File 1992-0055

Name: Ptarmigan Ridge - Filing #4 - Final Plat in RSF-4 Zone

COMMUNITY DEVELOPMENT DEPARTMENT - DAVE THORNTON
File #55-92 Ptarmigan Ridge filing 4 - **REVISED REVIEW COMMENTS:** (October 14th)

SECTION B - B

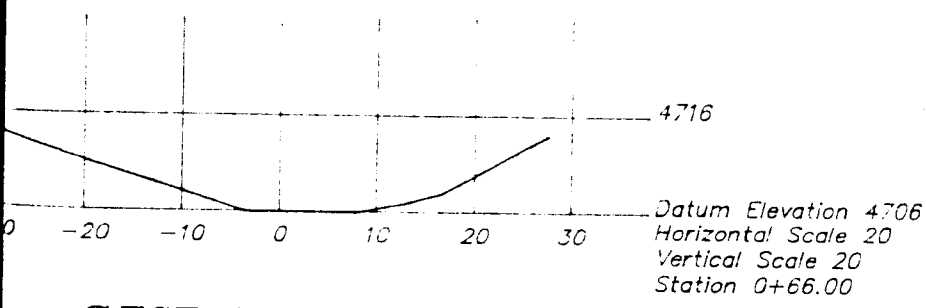
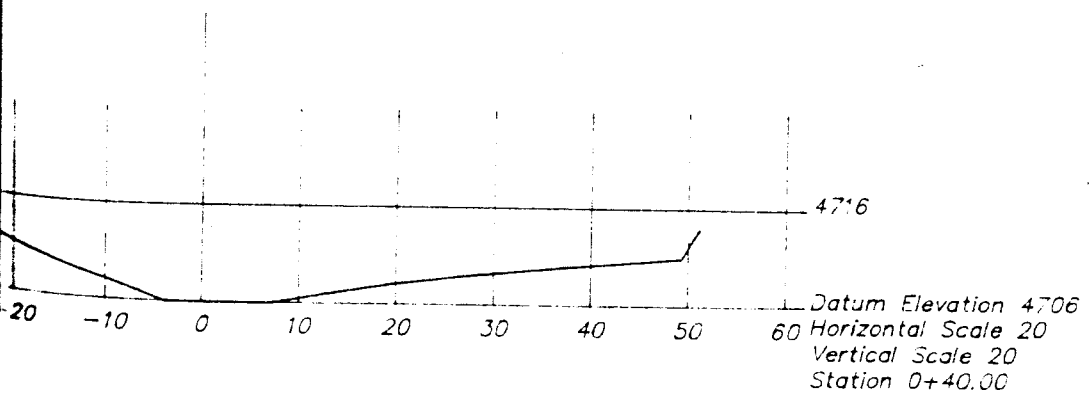
- FULL 100 YR VOLUME REQ'D
 BELOW FL ELEV OF 4713.57
- INDICATE HEREON WHAT THE 100 YR
 24 HR STORM RUNOFF VOLUME IS.
